CONSTRUCTION SUMMARY

Summer Ridge Estates Inc.

LOT NUMBER	PHASE	HOUSE TYPE	CLOSING DATE
012 BLOCK 290	1	FRENCH ROSE (25-04 B 4) ELEV B 4 BEDROOM	03-Feb-26

BLOCK 290 - TH. 12 25-04 FRENCH ROSE EL. B 4 BEDROOM 2385 SQ. FT.

LOWER LEVEL
ELEV. B

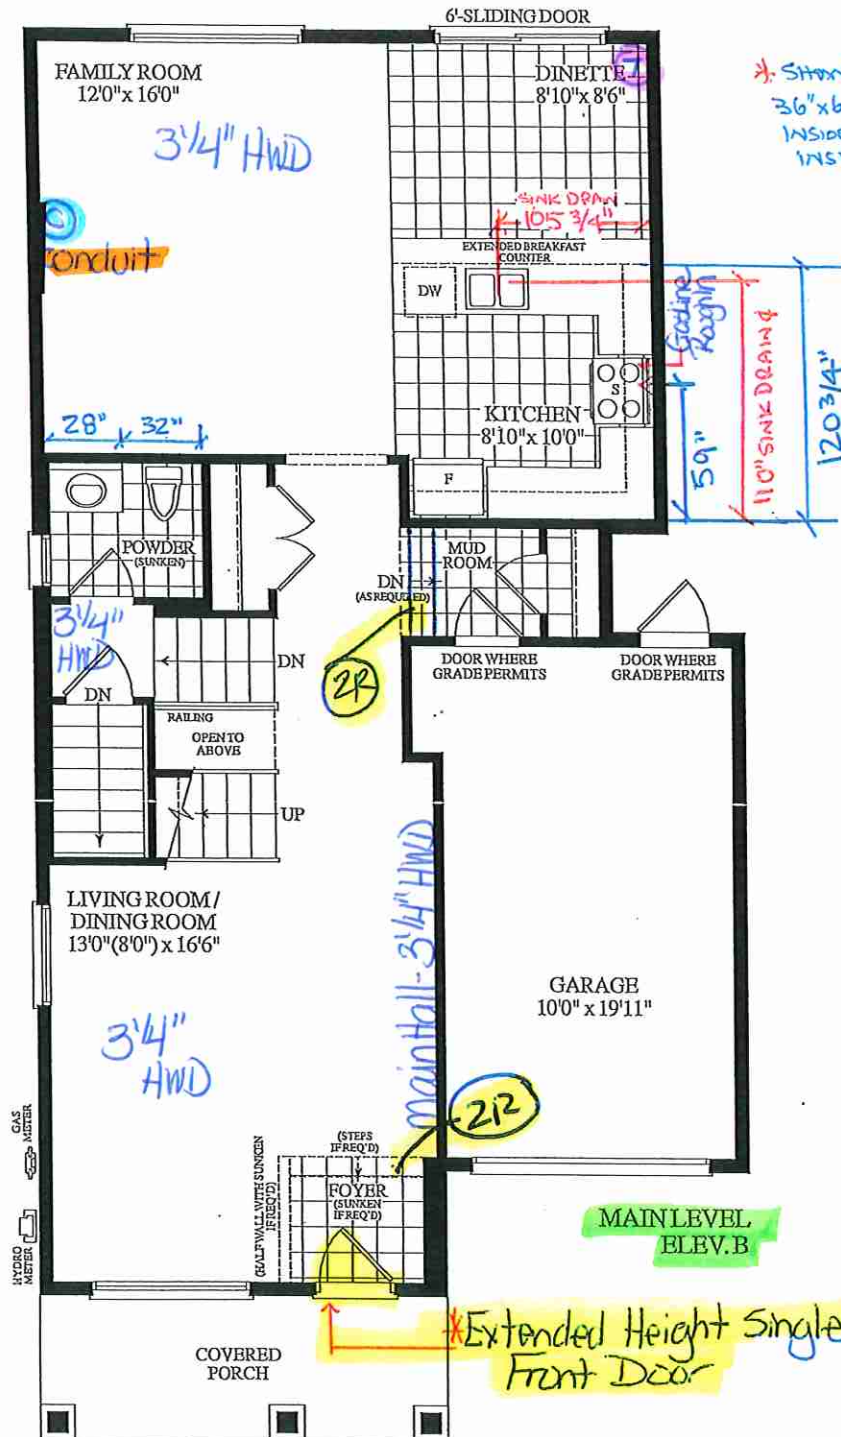
1 - BASEMENT - Install UPGRADE 200 AMP SERVICE in lieu of builders standard 100 Amp (See Sketch)
Note:

1 - FRONT EXTERIOR - FRONT DOOR - Install UPGRADE EXTENDED HEIGHT (Approx. 8") SINGLE FRONT DOOR (Delete Transom Window Above) with Glass in lieu of builder standard height single front door (See Sketch)
Note:

1 - KITCHEN - Install GAS LINE ROUGH-IN (Includes Additional Applicable Electrical) at stove area of kitchen (See Sketch)
Note:

OPT. UPPER LEVEL
ELEV. B
4 BEDROOM LAYOUT

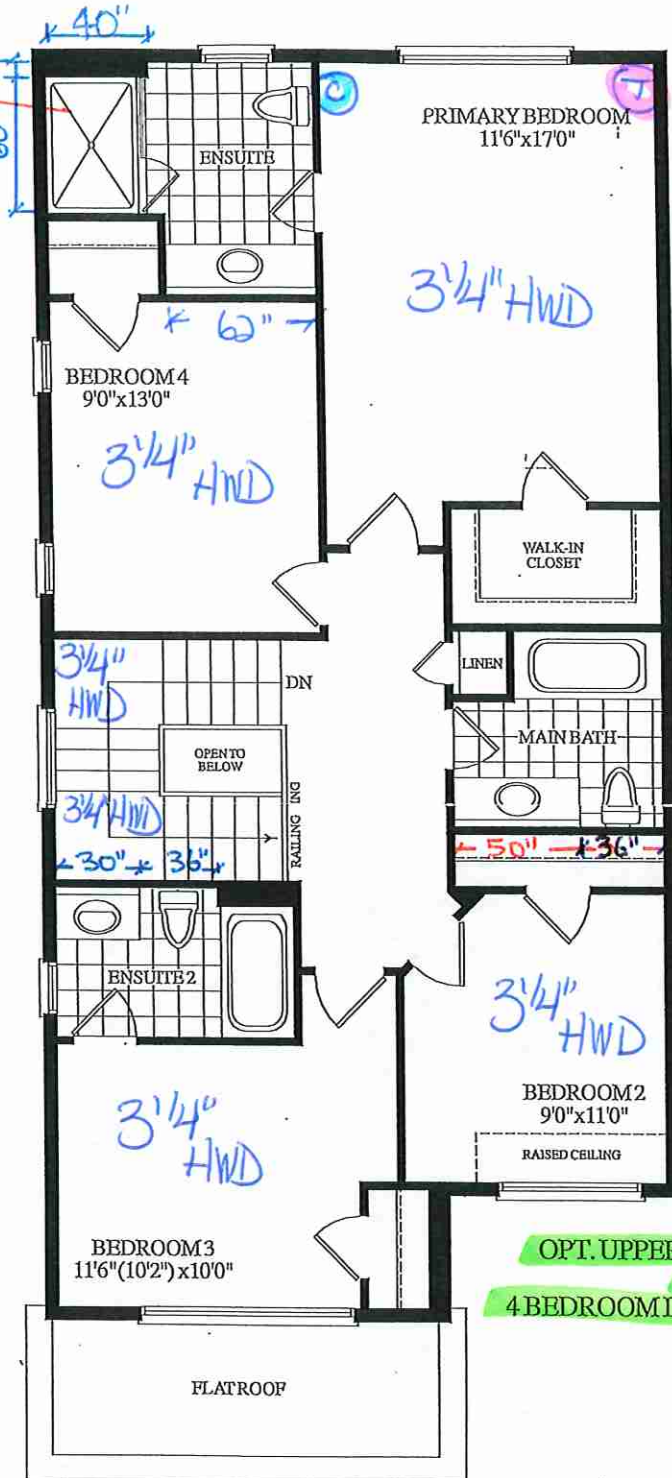
1 - Install Standard Cable Rough-Ins (x2) and Install Standard Telephone Rough-Ins (x2) (See Sketch)

1 - 2ND FLOOR BEDROOMS - FLOORING - Install prefinished 3 1/4" x 3/4" VINTAGE RED OAK NATURAL HARDWOOD (Character Pearl) in lieu of builders standard broadloom. To be installed throughout 2nd floor bedrooms, where applicable.

Note: To Include; Primary Bedroom, Bedroom #2, Bedroom #3 and Bedroom #4 (See Sketch)

KITCHEN PLAN

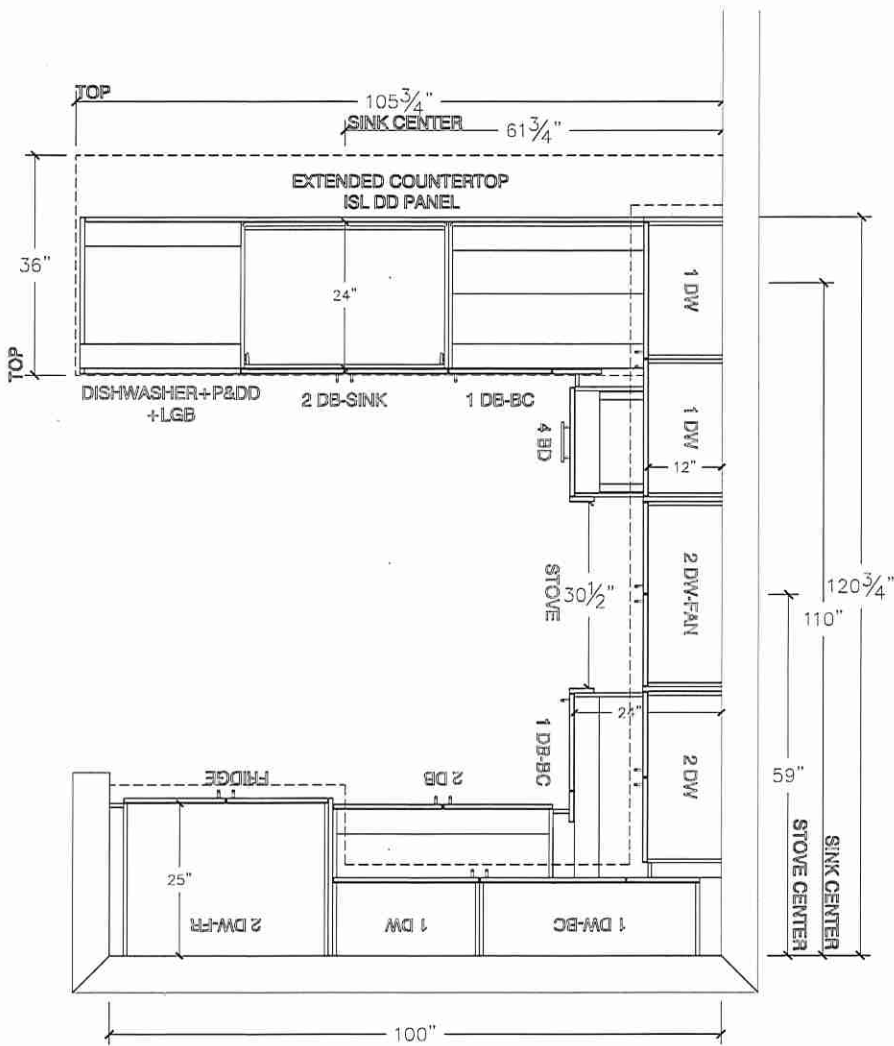
1 - KITCHEN & BATHROOMS - Purchaser has DECLINED All Upgrades offered during decor appointment at the decor centre for kitchen & bathroom cabinetry. Standard Kitchen Layout & Standard Bathroom Vanities to be installed as per standard plan. (See Sketch)

1 - KITCHEN - COUNTERTOP - Install Builders Standard Stone Countertop – EVEREST WHITE GALAXY with STANDARD " A " EDGE PROFILE - To be installed throughout kitchen, where applicable (does not include stone backsplash) (See Sketch)

MASTER ENSUITE PLAN

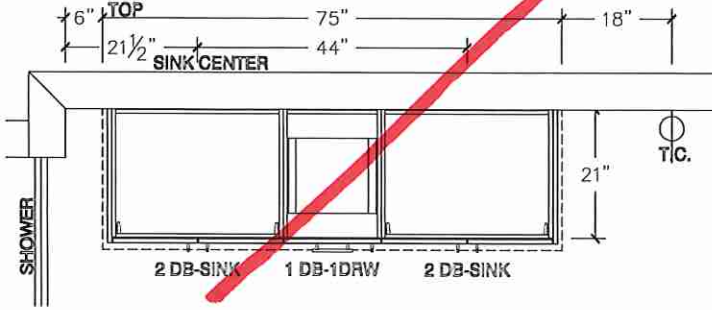
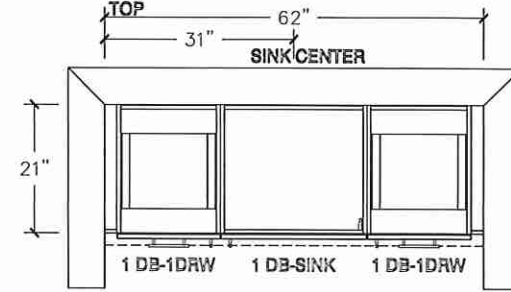
1 - PRIMARY ENSUITE - FLOORING - Install UPGRADE #1 TILES - 18x18 VERSAIL GRIS - To be installed throughout primary ensuite floor, where applicable. To be Installed Straight (See Sketch)

MAIN BATH PLAN

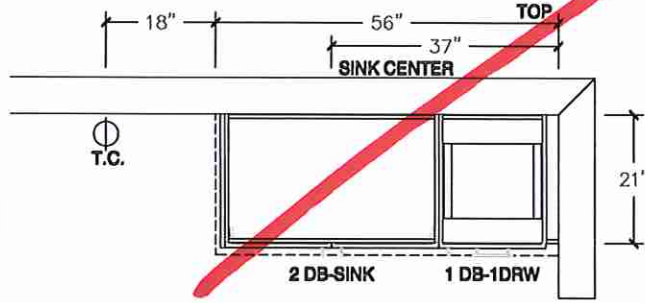
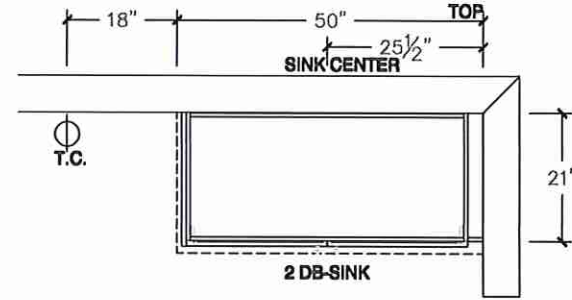
1 - MAIN BATH - FLOORING - Install UPGRADE #1 TILES - 18x18 VERSAIL GRIS - To be installed throughout main bath floor, where applicable. To be Installed Straight (See Sketch)

ENSUITE 2 PLAN OPT 2ND FLOOR

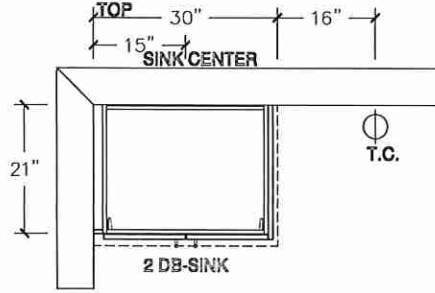
1 - ENSUITE #2 - FLOORING - Install UPGRADE #1 TILES - 18x18 VERSAIL GRIS - To be installed throughout ensuite #2 floor, where applicable. To be Installed Straight (See Sketch)
